**Submission/Observation to An Bord Pleanála RE: Upgrade and Enhancement of  
Woodquay Park and Surrounding Public Realm.**

Mr. Robert Grealish  
8 Walsh's Terrace  
Woodquay  
Galway  
H91DX7H  
05/11/24

Pursuant to the application for planning permission from An Board Pleanála for the upgrade and enhancement of Woodquay Park and surrounding public realm located on the R866 Road Woodquay, Galway City Co. Galway I wish to make the following observations relating to *'the implications of the proposed development for proper planning and sustainable development in the area concerned'*:

Fig A

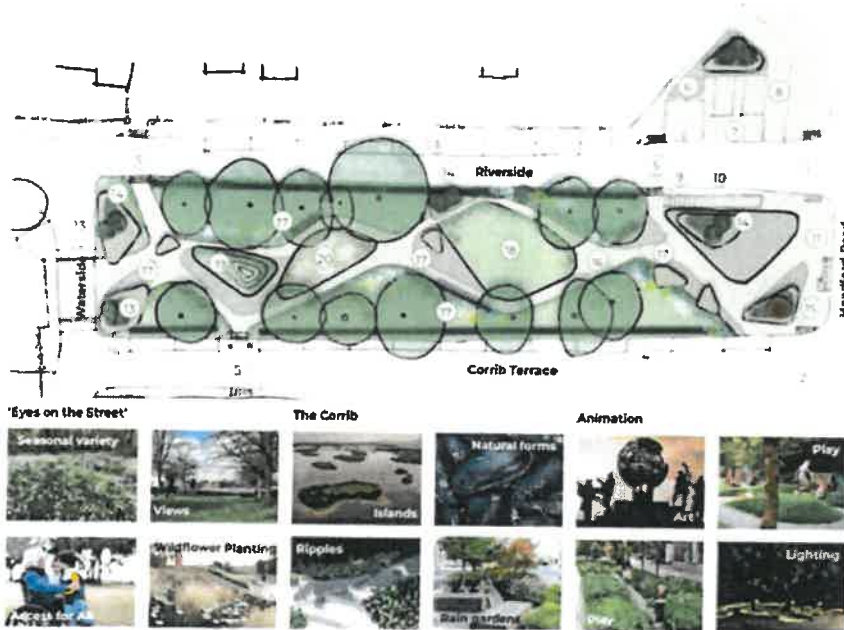
It is clear from the Revised Concept Design (Fig A) that the 10 Cycle Stands and 5 Motor Cycle Spaces were to be located at the edge of the park away from my property. This would enable patrons to park their bicycles and motor cycles and immediately enter the park without crossing a main thoroughfare thus satisfying *proper planning and sustainable development*. As a member of the Woodquay Residents Association, I attended the meeting where public consultation was sought in relation to the proposed Revised Concept Design.

Fig B

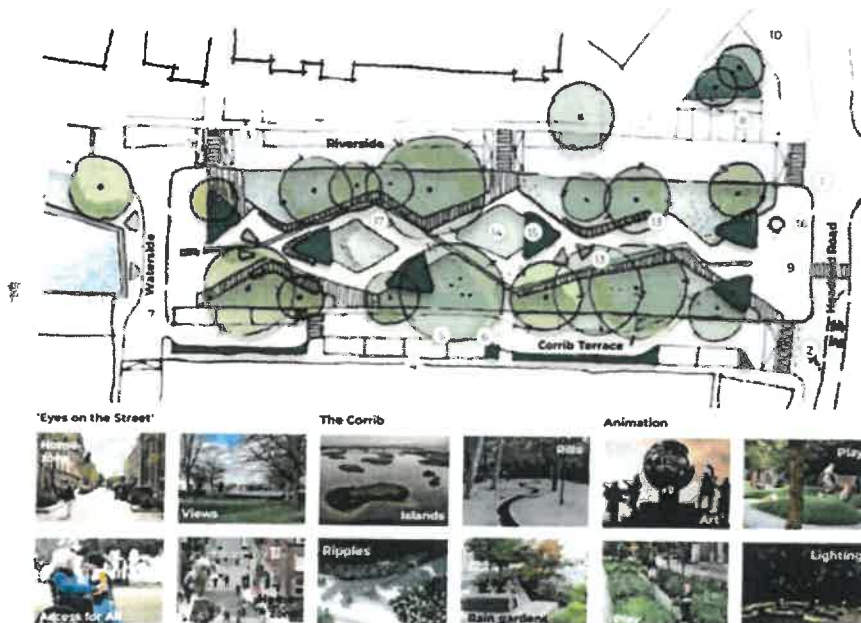
In June the Developed Concept Design (Fig B) contained a significant change with the Cycle Station to be relocated in front of my property 8 Walsh's Terrace. The most recent planning application now contains a further amendment which impacts my property. 4 Motor Cycle spaces have now been added to the 10 Cycle Hire Stands in an already confined area which will be further restricted due to infrastructural changes demanded by the recently approved Galway BusConnects Cross-City Link. In the interests of *proper planning and sustainable development* I am asking the Board to revert to the initial design proposed in the Revised Concept Design Fig A which locates the 10 Cycle Hire Stands (10) and 5 Motor Cycle Spaces (9) along the boundary of the park, with the area directly in front of 8 Walsh's Terrace free of any and all obstructions.

Fig C

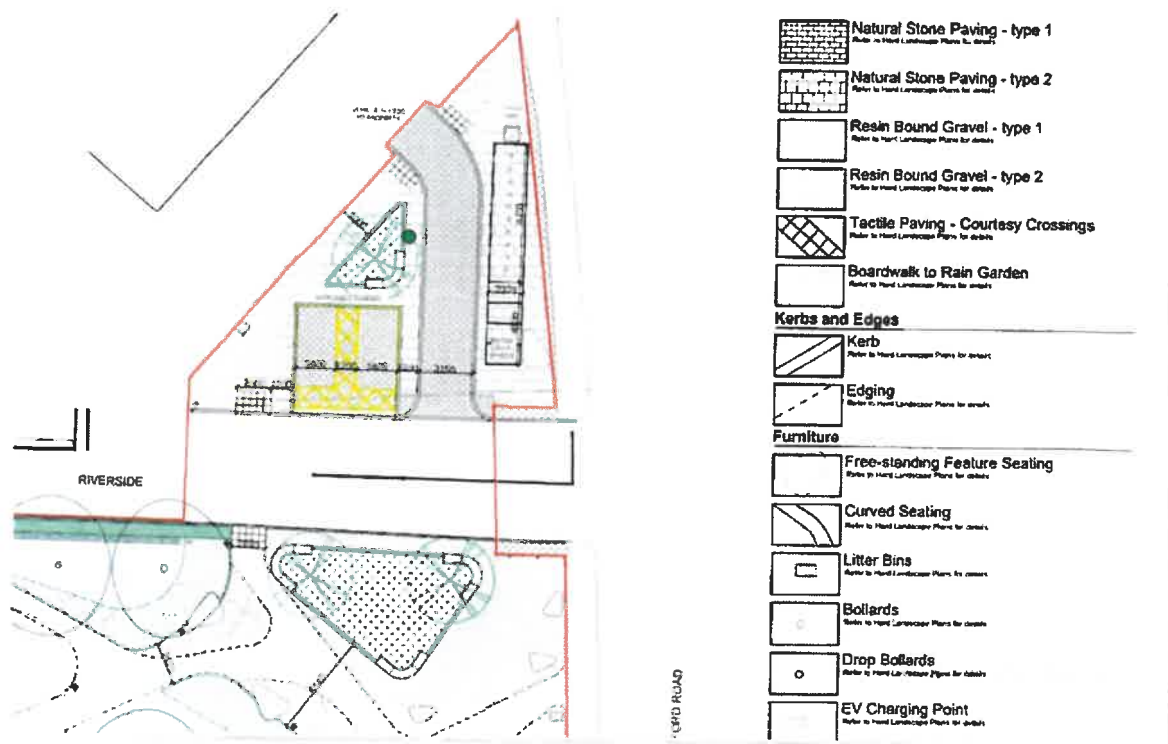
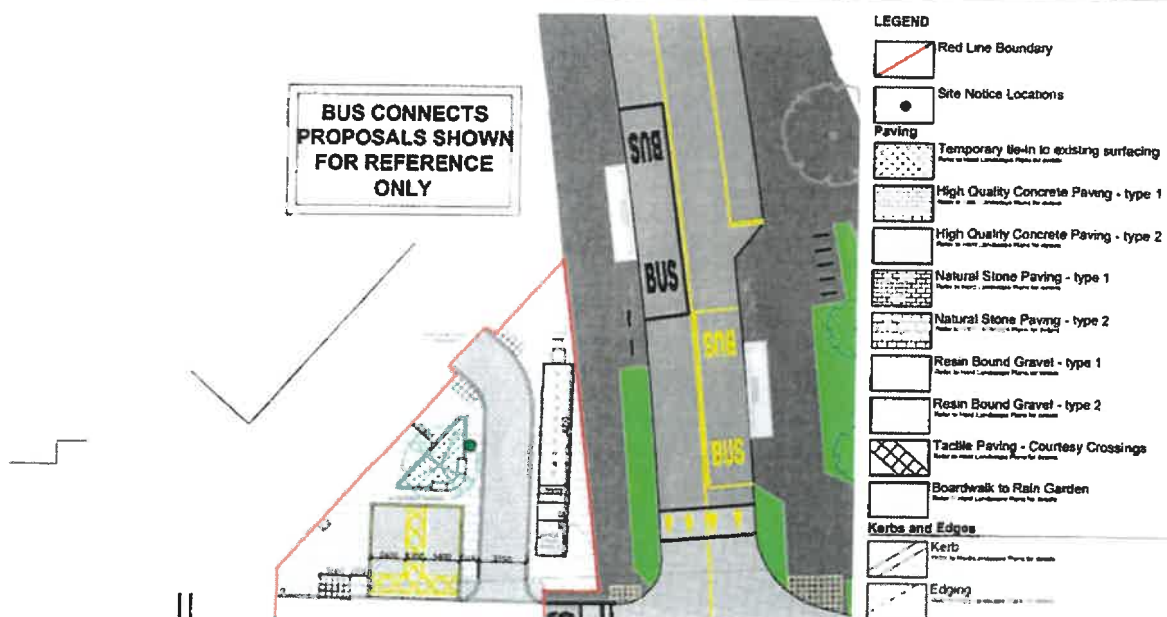
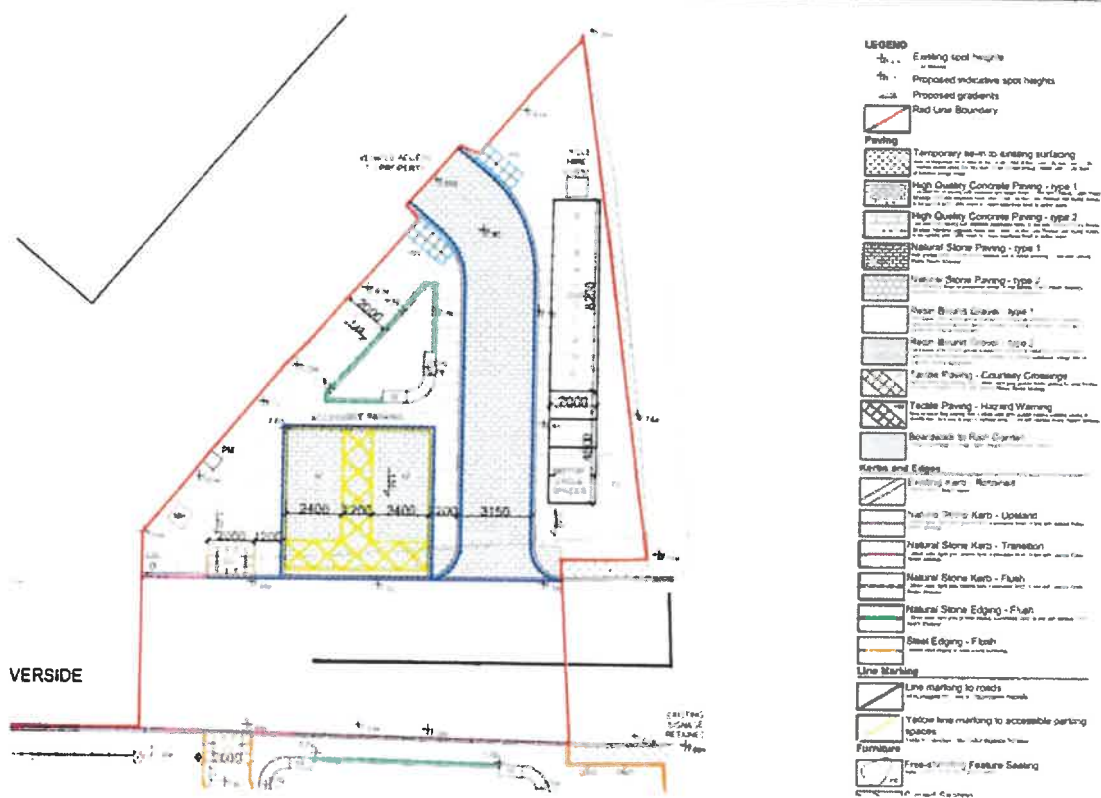
Of immediate concern is the vehicular access to my property at 8 Walsh's Terrace. As you will note from Fig C, Fig D & Fig G – the proposed width of the new access road to my house is set at 3,150mm (3.15 meters). As per the planning granted by Galway City Council on my property

(Planning Register Reference No. 11/154 - see Fig H below) the vehicular entrance is fixed at 3.2m in accordance with the requirements of the Galway City Council Development Plan (21-011 – 2017). It is my contention that the proposed access road should, at the very least, exceed this fixed opening of 3.2 meters and should be constructed to the industry standard of 3.6 meters (12 feet).
